RE: 071825_VA Credit Union, Blacksburg, VA - BMEP 1st rev

Virginia Credit Union Branch renovation 202 N. Main St.

A. Comments & Responses

Itemized below are responses to the review comments for project #071825, dated 8/13/25. Replies to comments are listed in the order in which they appear within the reviewed and marked up PDF "071825_VA Credit Union, Blacksburg, VA - BMEP 1st rev" from top to bottom of each sheet.

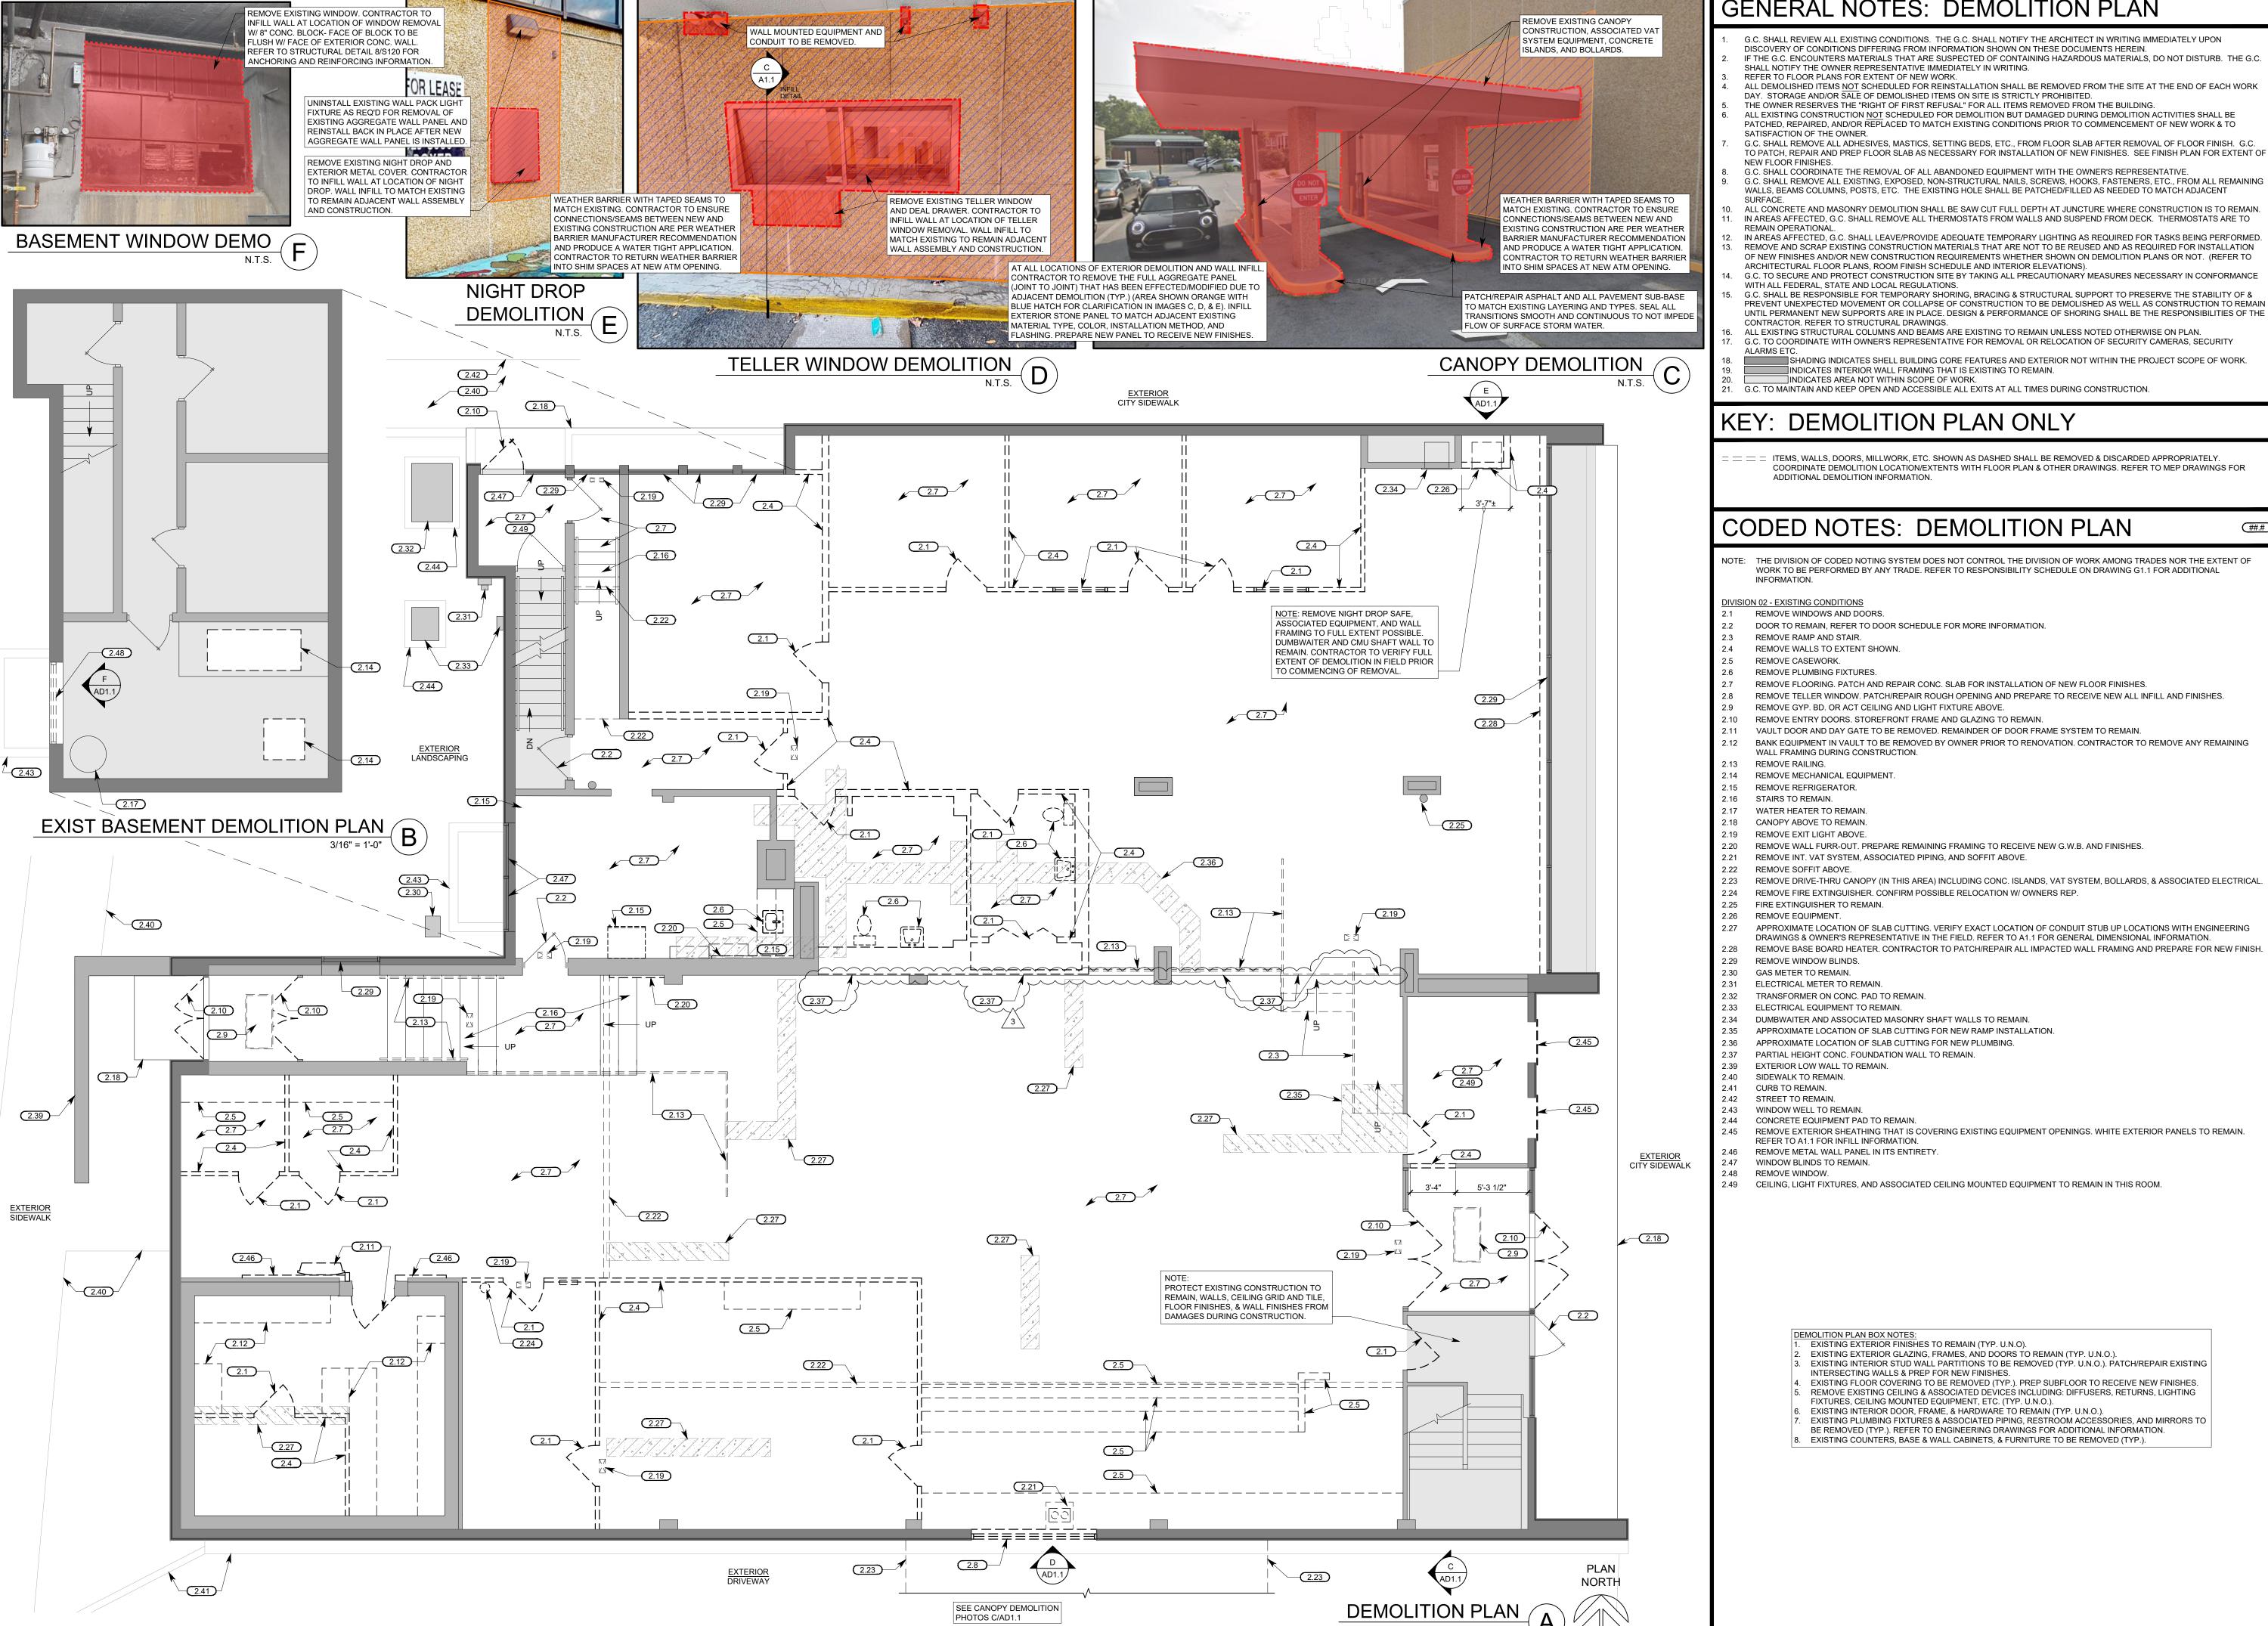
1. Reviewer's Comment (Sheet G1.1 Building Code Summary):

Please let the reviewer know when the building in which this facility is being fit out was originally built. Buildings that date original construction prior to Jan 1, 1985 must include an asbestos survey. If this is required provide the report.

2. Reviewer's Comment (Sheet G1.1):

The reviewer notes that the governing code on this project will be the 2021 VEBC. The application of every other code or standard in this list is limited or governed by reference from the VEBC. It is not possible for the VEBC and VCC to both be governing codes. We recommend editing this list accordingly.

3. Reviewer's Comment (Sheet G1.1):

This list seems to be a mix of old and new, is it the intent of this project to bring elements from the original construction into compliance with the current code.

4. Reviewer's Comment (Sheet G1.1 Plumbing Fixture Count Table):

Does this table reflect what is there or what is needed and provided. Note that when the project results in requiring added facilities from what is already there, the Change of Occupancy is triggered.

Building Code Summary on sheet G1.1 has been updated to include the requested information. Per request, please see included Asbestos Report.

Acknowledged, see attached revised Sheet G1.1. for updated Building Code Summary.

Acknowledged, see attached revised Sheet G1.1 with added clarifying note to Building Code Summary.

The table reflects plumbing fixture counts that are required by Virginia Plumbing Code as referenced by the Virginia Existing Building Code and plumbing fixture counts that are provided as part of this construction project. Please note that the project does not require additional toilet rooms or drinking fountains. Extra toilet rooms and drinking fountains were provided at the Owner's request and not due to an increase in occupant load. A service sink was added to meet code. See attached revised Sheet G1.1 with added clarifications indicated at Plumbing Fixture Count Table.

- A. Building Code Summary:
 - 1. Added existing building construction date information.
 - 2. Removed "VBC 2021 (IBC 2021 w/ Amendments)" and added notes clarifying applicable codes used.
 - 3. Updated energy code indicated "VECC".
 - 4. Clarification: Removed "No Scope" for basement under Occupant Load Table.
 - 5. Added clarifying note to supplement Plumbing Fixture Count Table.

ENLARGED RESTROOM PLAN 1/2" = 1'-0" A

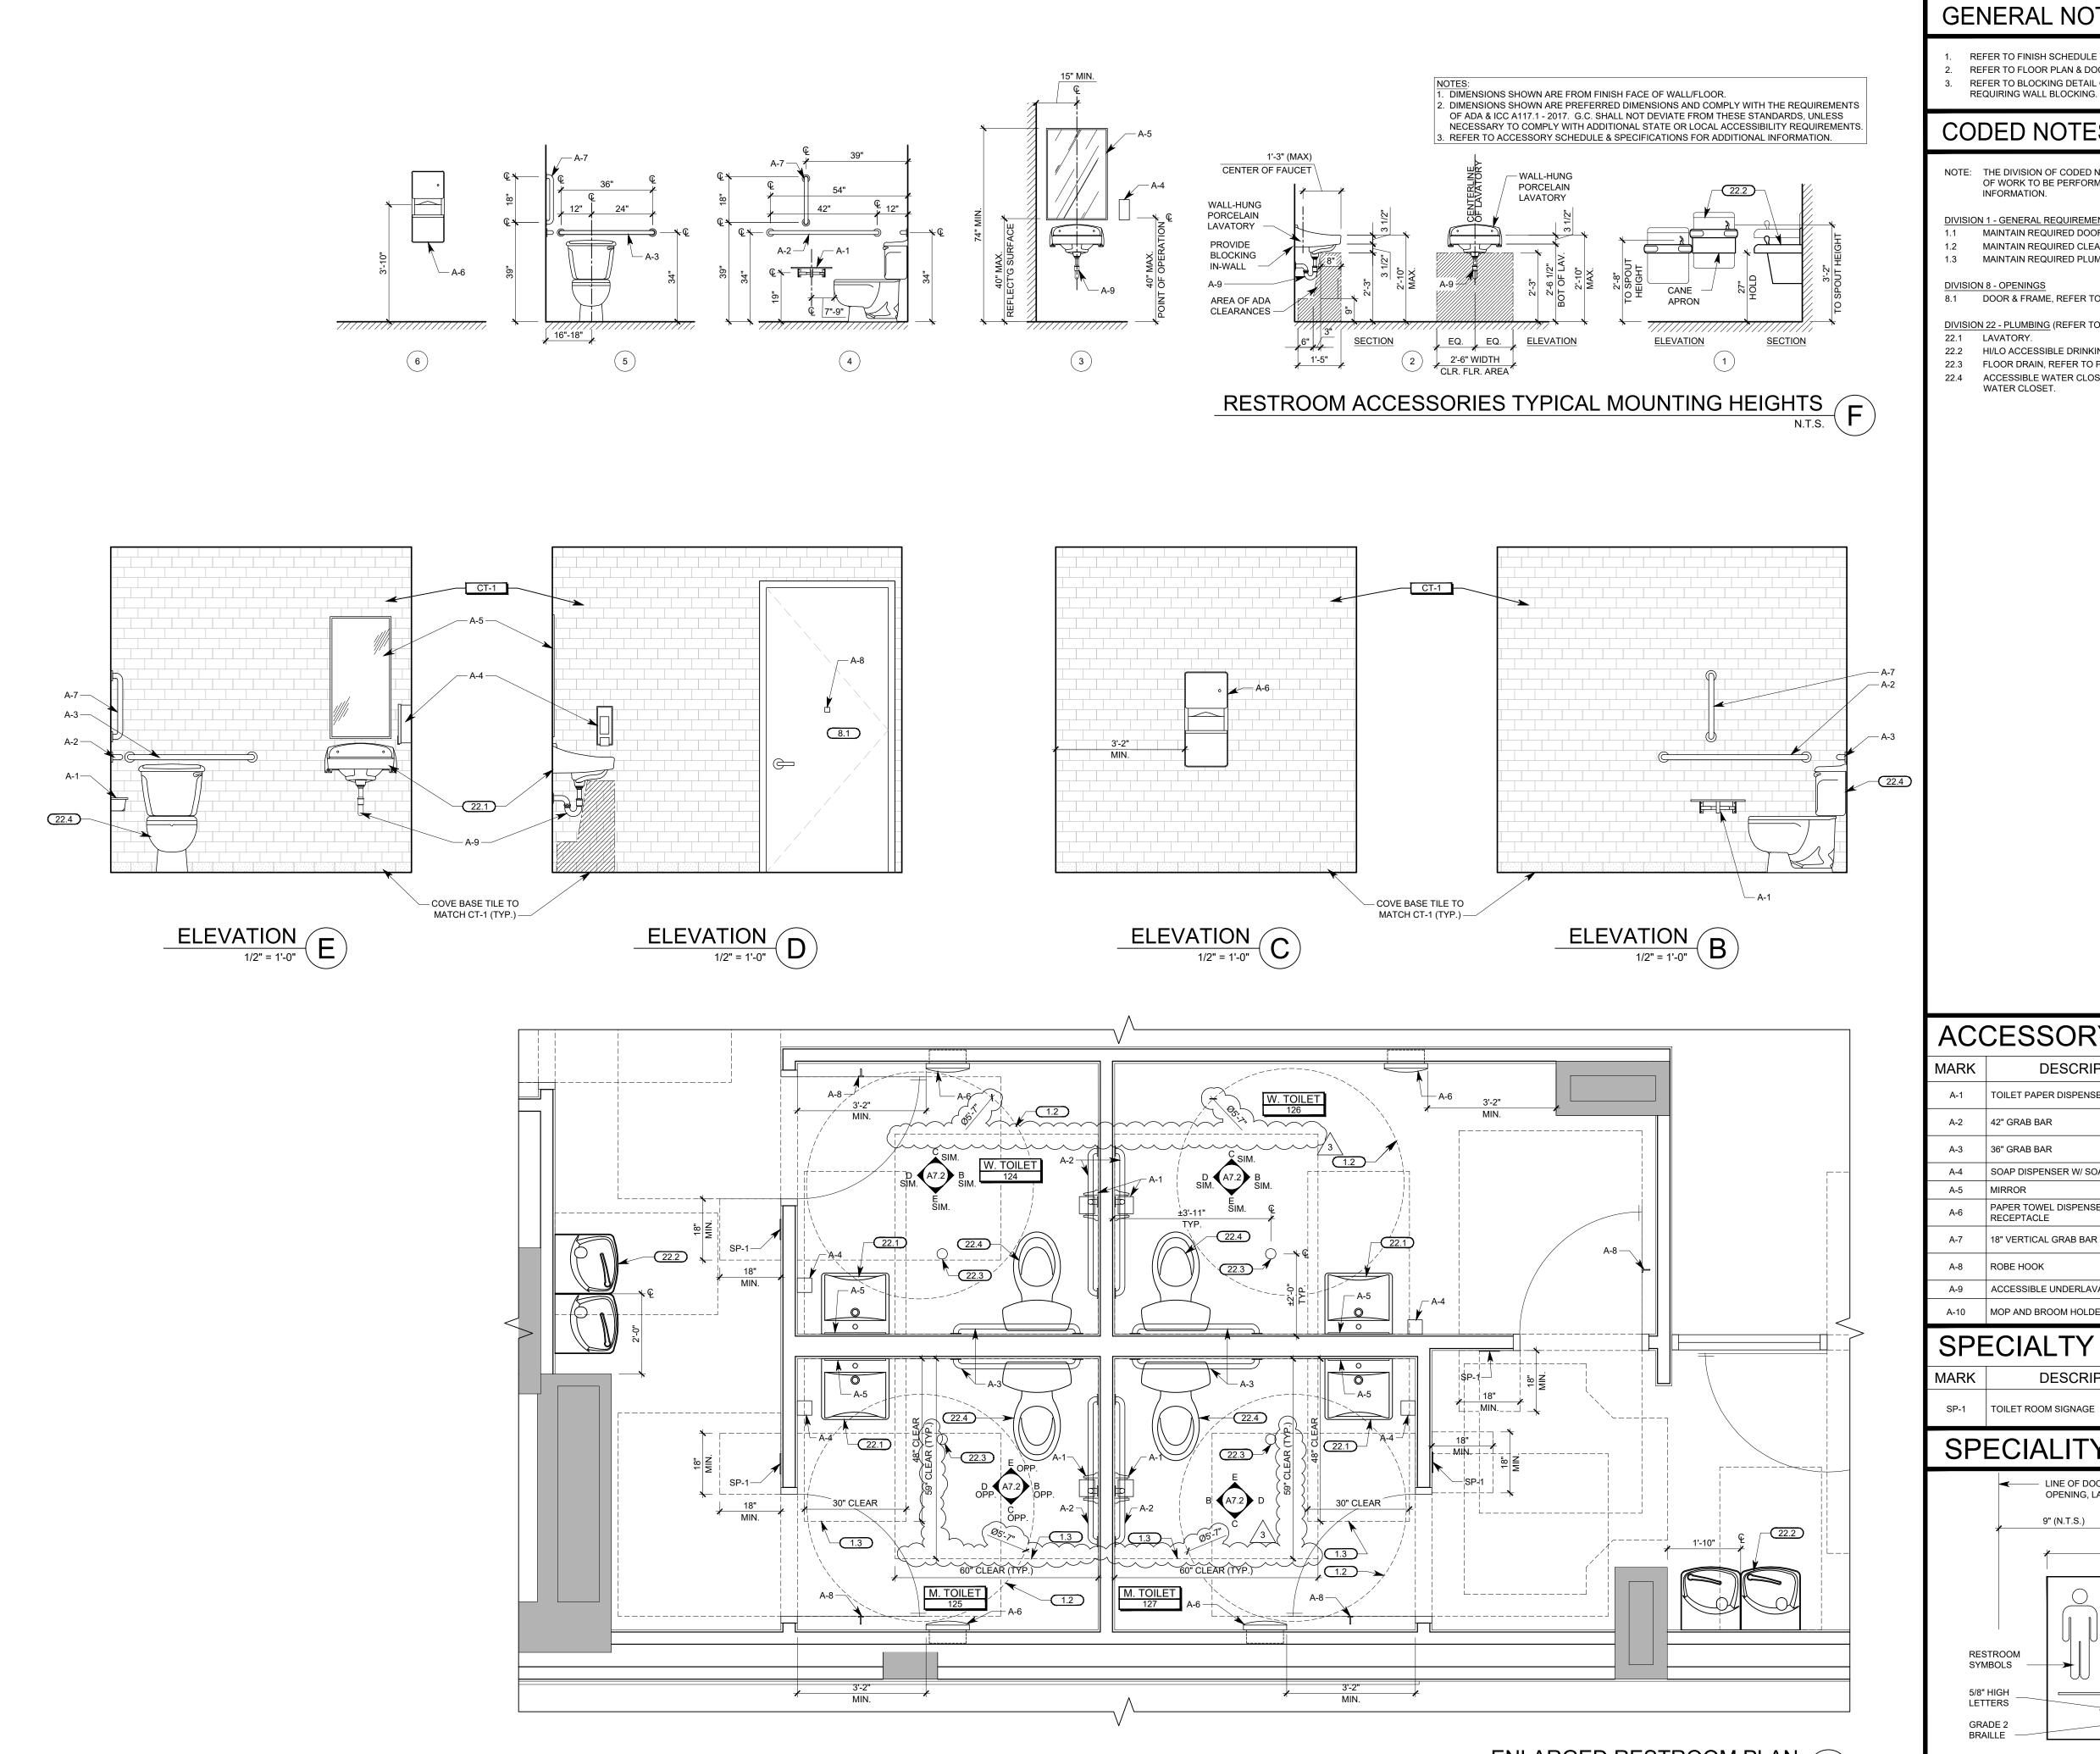
5. Reviewer's Comment (Sheet A7.2 Enlarged Restroom Plan):

The dimensions appear to not be correct for a floor mounted toilet (59 in versus 56 inches). Please review 2017 A117.1 and clarify. Also add a dimension for the turning radis since that has changed after a long period of being the same in prior standards.

Response:

Acknowledged, Coded Notes 1.2 and 1.3 on Sheet A7.2 indicate to maintain required clearances and turning radius. Please see attached revised Sheet A7.2 with additional clarifications as requested.

- A. Plan A:
 - 1. Adjusted clear floor space at toilet compartments to be 59" deep.
 - 2. Added dimension to turning radii.
